Subject: MHI's Response to US-APWR DCD RAI No. 268-2181 Revision 1

Reference: 1) "Request for Additional Information No. 268-2181 Revision 1, SRP Section: 04.05.01 – Control Rod Drive Structural Materials" dated 3/9/2009

Response to Request for Additional Information No. 268-2181,
Revision 1

RAI NO.: NO. 268-2181 REVISION 1
SRP SECTION: 04.05.01 - CONTROL ROD DRIVE STRUCTURAL MATERIALS
APPLICATION SECTION: 4.5.1
DATE OF RAI ISSUE: 3/9/09

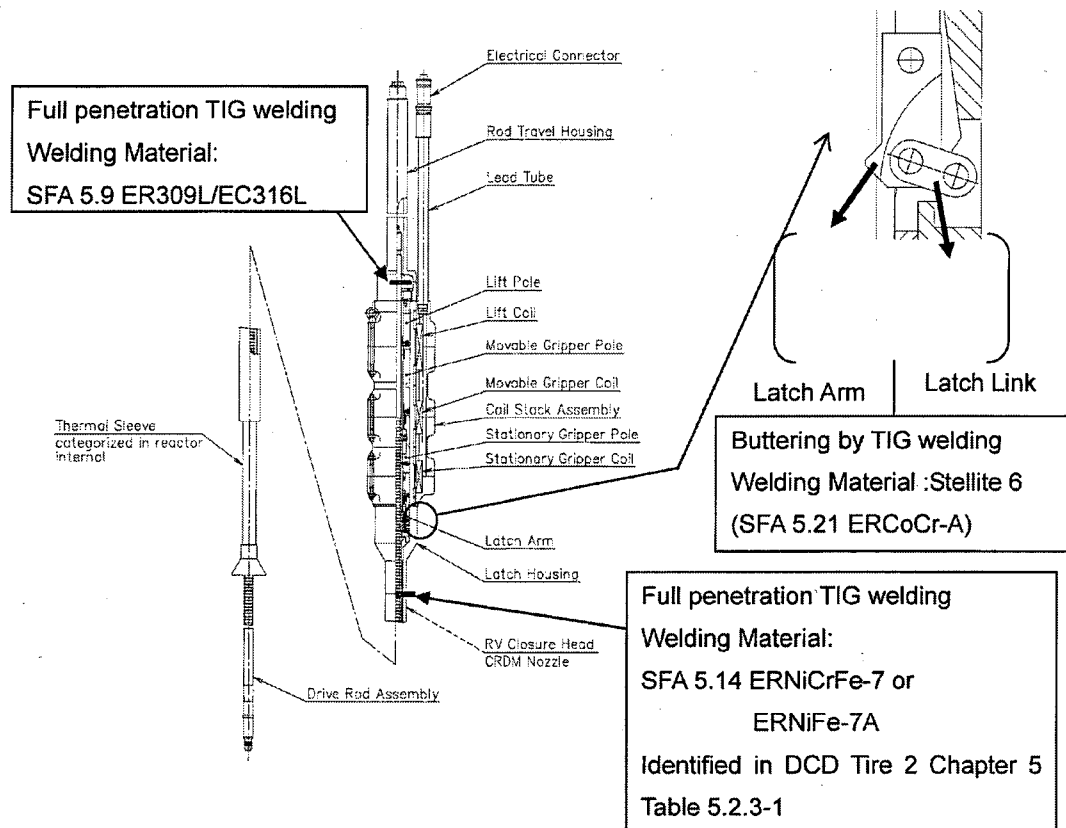
3. Table 4.5-1 lists weld filler material specifications as meeting SFA-5.9 or SFA-5.4. The staff requests that the applicant modify Table 4.5-1 to include weld filler metal classifications. In addition, the staff requests that the applicant provide a sketch of the CRDM indicating the location of all welds with a description of each weld including welding requirements.

3. Welding locations and welding requirements are shown in sketches below.

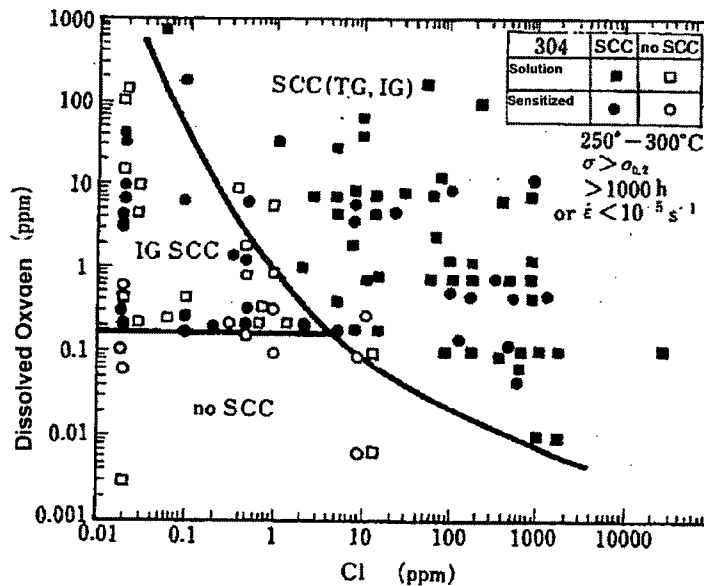
SA-182 Grade F316, SA-479 type 304 and SA-213 Grade TP304 permit a carbon content of up to 0.08%. The applicant states that it will follow RG 1.44, which recommends a carbon content not to exceed 0.03%. However, the applicant's Table 4.5-1 does not contain a supplemental requirement limiting carbon to 0.03%. The staff requests that the applicant modify Table 4.5-1 to include a note that limits carbon to no greater than 0.03% for austenitic stainless steels. In addition, the staff requests that the applicant list FSAR Subsection 4.5.1 in Table 1.9.1-1 under the line item for RG 1.44.

RG 1.44 allows exceptions to the 0.03% requirement such as material exposed to reactor coolant which has a controlled concentration of less than 0.10 ppm dissolved oxygen at all temperatures above 200°F during normal operation. Furthermore, MHI understands that the NRC position in the RG 1.44 is primarily concerned with BWR environmental conditions.

Dissolved oxygen in PWR primary water is controlled under 0.1 ppm. The standard value of the dissolved oxygen is 0.05 ppm. These are identified in the DCD Tire 2 Chapter 5 Table-5.2.3-2. This dissolved oxygen area is under the limit of SCC environment condition.

The following figure shows the relationship between SCC potential and the chemical condition of dissolved oxygen and chloride ion by M. O. Speidel which was presented at the 1st U.S. – Japan Joint Symposium on Light Water Reactors, Fuji, Japan (1978). From the figure below, it can be seen that the US-APWR chemical condition is not in the SCC area. Furthermore, materials in operating PWR plants constructed from Type 304 stainless steel with higher carbon content, have not experienced the SCC problems reported for BWRs, which further supports the conclusion that the higher carbon content is acceptable.

Therefore MHI considers low carbon stainless steel is not necessary in the primary water of the PWR.
